SEMINOLE COUNTY GOVERNMENT
1101 EAST FIRST STREET, 2ND FLOOR, WEST WING
SANFORD, FLORIDA 32771

PROJECT NAME:	S BEARDALL PROPERTY - PRE-APPLICATION	PROJ #: 25-80000051
APPLICATION FOR:	DR - PRE-APPLICATION DRC	
APPLICATION DATE:	4/18/25	
RELATED NAMES:	EP MATTHEW SANDS	
PROJECT MANAGER:	ANNE SILLAWAY (407) 665-7936	
PARCEL ID NO.:	04-20-31-300-0340-0000	
PROJECT DESCRIPTION	PROPOSED SITE PLAN TO CONSTRUCT A BUSINESS HEADQUARTERS ON 6.10 ACRES IN THE PD ZONING DISTRICT LOCATED ON THE WEST SIDE OF BEARDALL AVE, NORTH OF MOORES STATION RD	
NO OF ACRES	6.10	
BCC DISTRICT	5: HERR	
CURRENT ZONING	PD	
LOCATION	ON THE WEST SIDE OF BEARDALL AVE, NORTH OF MOORES STATION RD	
FUTURE T LAND USE-	HIPAP	
APPLICANT:	CONSULTANT:	
MATTHEW SANDS SANPIK, LLC 1424 N RONALD REAGAN BLVD STE LONGWOOD FL 32750 (407) 450-6969 M.SANDS@SANPIKINC.COM	N/A

PROJECT MANAGER COMMENTS

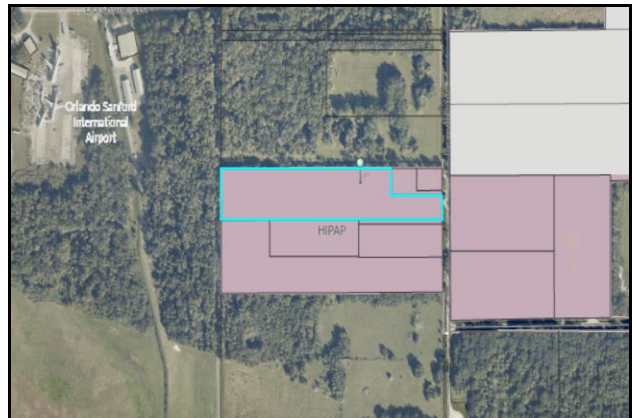
- The subject property has a Future Land Use of HIP-AP (Higher Intensity Planned Development – Airport).
- Staff strongly recommends contacting the City of Sanford regarding the proposed utility line installations scheduled for next year and the pre-annexation process. Once the utilities are in place, the city may require the Applicant to connect to the water and sewer lines along Beardall Avenue.

- The Applicant is proposing a new location for the parking area, which would require the Applicant to maintain a ten (10) foot landscape buffer along the eastern portion of the site, as specified on the Master Development Plan (MDP).

- The proposed relocation of the buildings and parking facilities to the designated laydown yard, along with the reduction in building footprints relative to the approved Master Development Plan (MDP), does not constitute an amendment to the MDP. The next step for the Applicant is to submit a Final Development Plan as an Engineered Site Plan.
